ARKANSAS NUCLEAR ONE, UNIT 2

AMENDMENT TO FACILITY OPERATING LICENSE

Amendment No. 37
License No. NPF-6

ATTACHMENT TO LICENSE AMENDMENT NO. 37

FIGURE 3.1-2

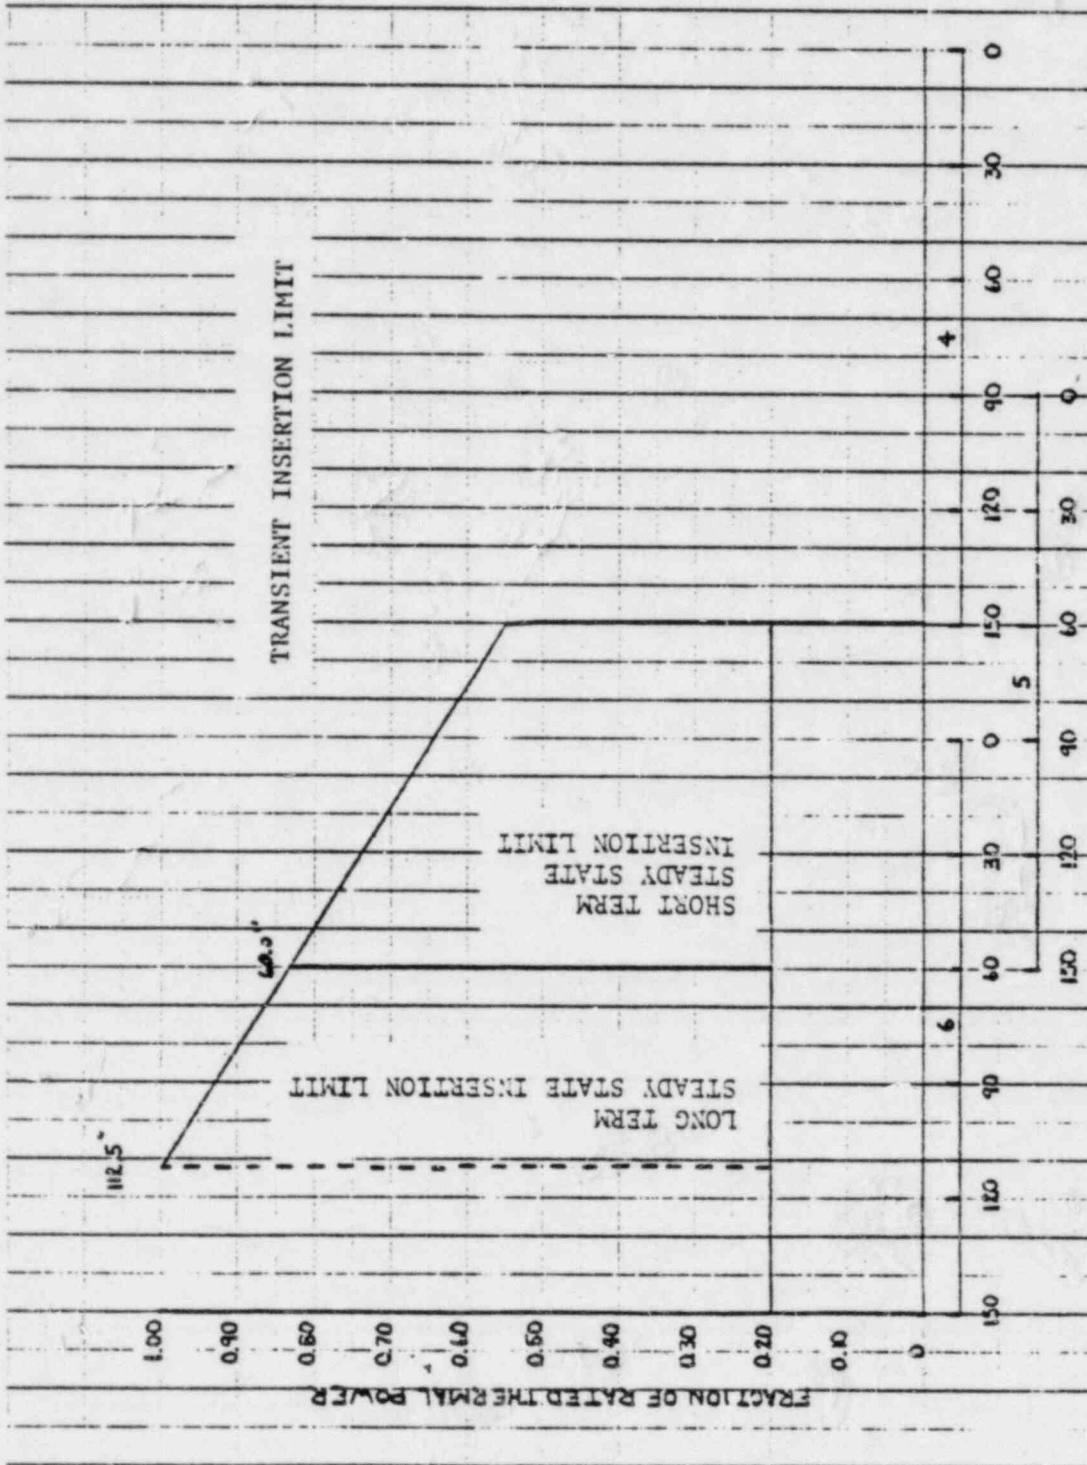
3.1.3.6 The regulating CEA groups shall be limited to the withdrawal sequence and to the insertion limits shown on Figure 3.1-2 with:

- a. CEA insertion between the Long Term Steady State Insertion Limit and the Transient Insertion Limit restricted to:
 1. ≤ 5 Effective Full Power Days per 30 Effective Full Power Day intervals, and
 2. ≤ 14 Effective Full Power Days per calendar year.
- b. CEA insertion between the Short Term Steady State Insertion Limit and the Transient Insertion Limit shall be restricted to ≤ 4 hours per 24 hour interval.

- c. With the regulating CEA groups inserted between the Short Term Steady State Insertion Limit and the Transient Insertion Limit for intervals > 4 hours per 24 hour interval, operation may proceed provided any subsequent increase in thermal power is restricted to $\leq 5\%$ of rated thermal power per hour.

FIGURE 3-1-3
PART LENGTH CEA INSERTION LIMIT VS. THERMAL POWER
PLATE WITHDRAWAL - INCHES

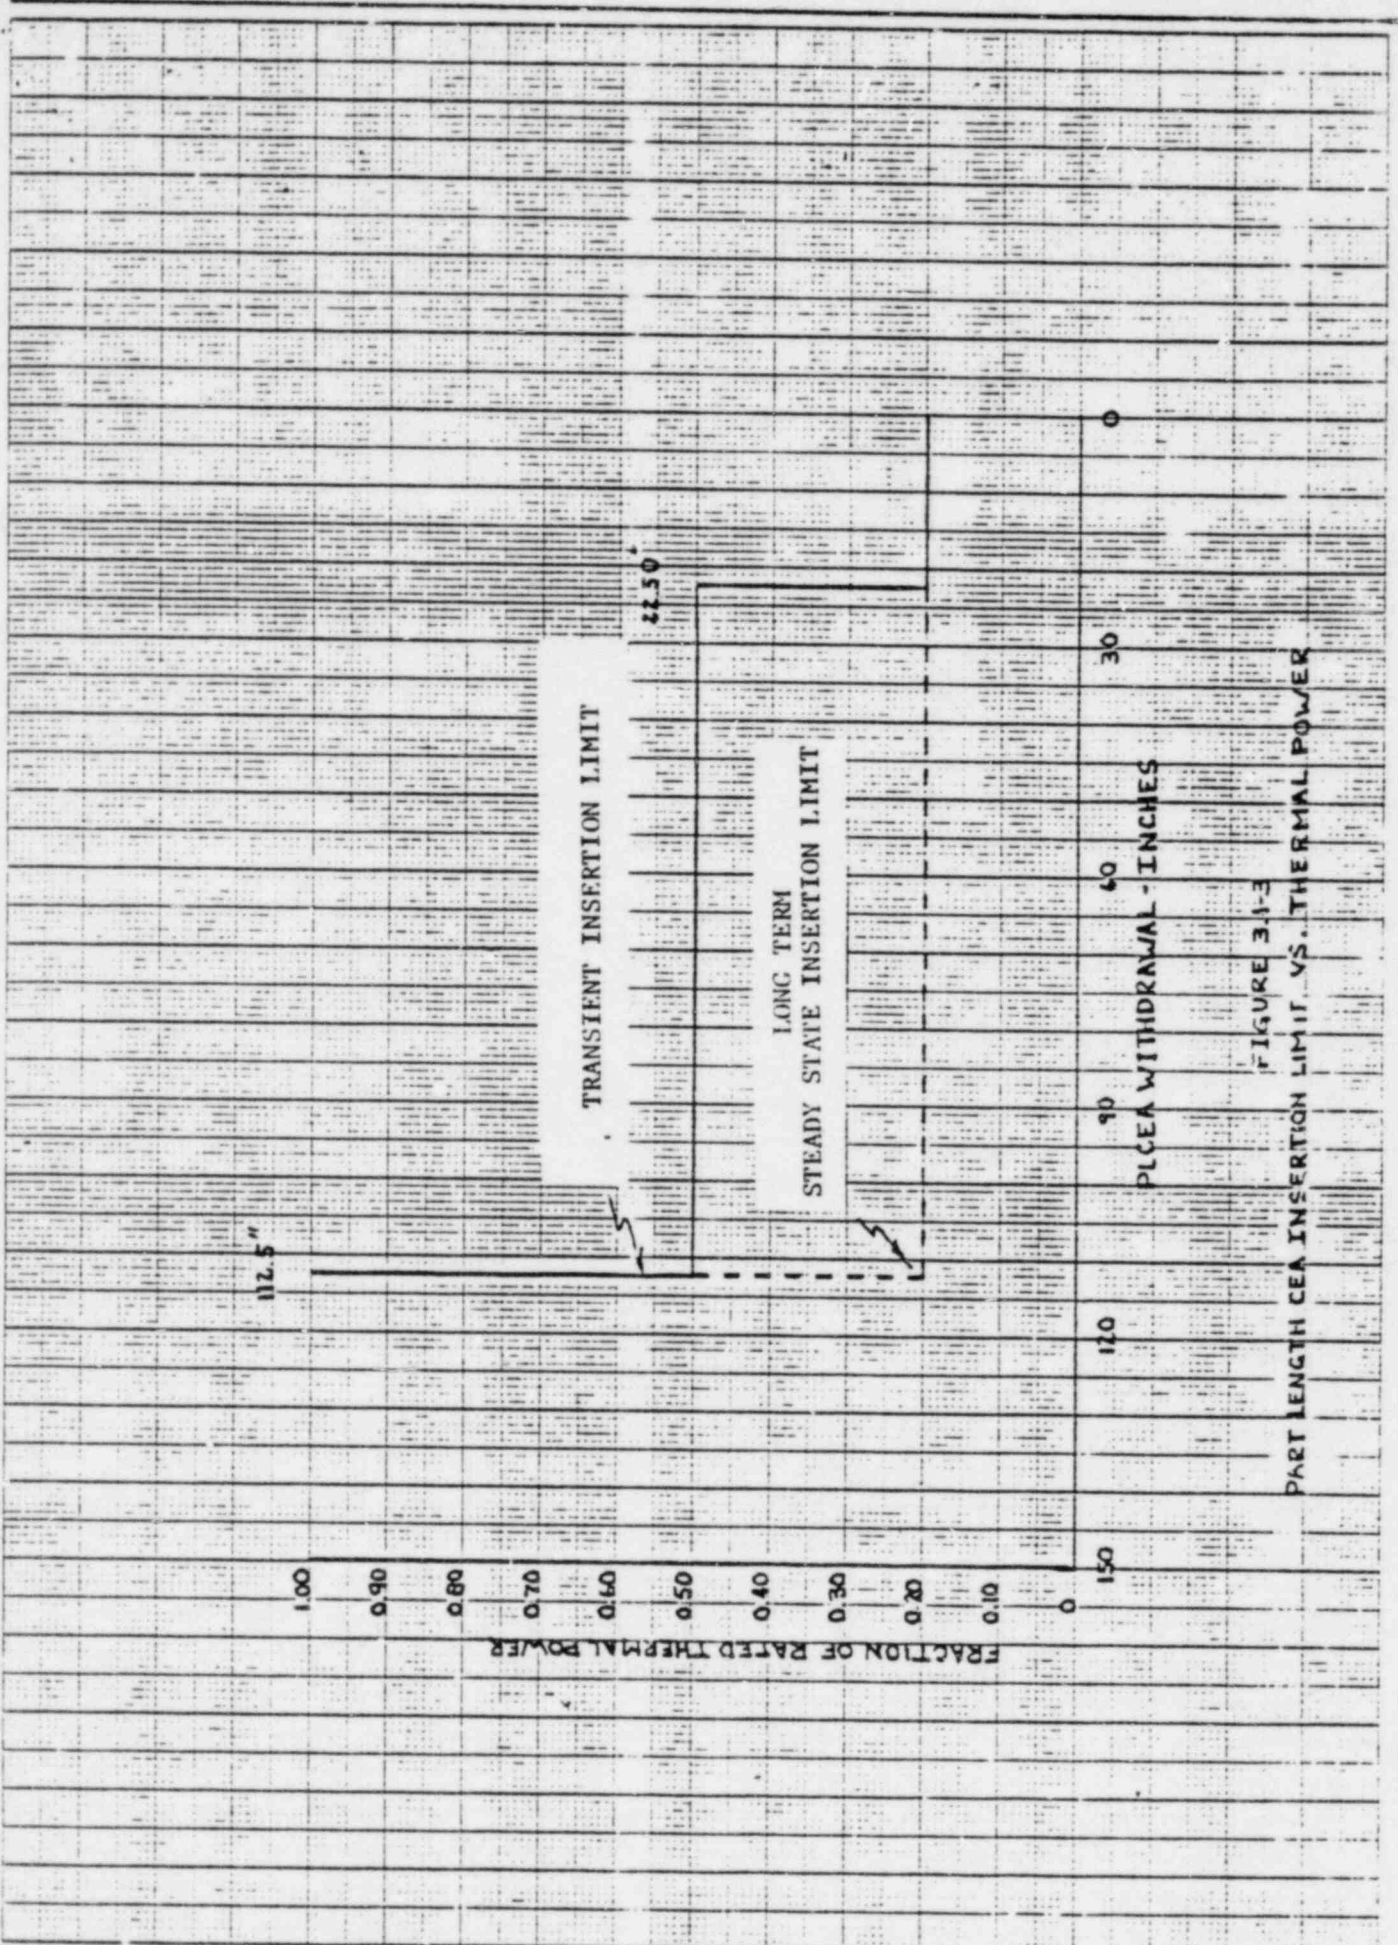
3.1.3.7 The part length CEA group shall be limited to the insertion limits shown on Figure 3.1-3 with PLCEA insertion between the Long Term Steady State Insertion Limit and the Transient Insertion Limit restricted to:

- a. ≤ 5 Effective Full Power Days per 30 Effective Full Power Day Interval, and
- b. ≤ 14 Effective Full Power Days per calendar year.
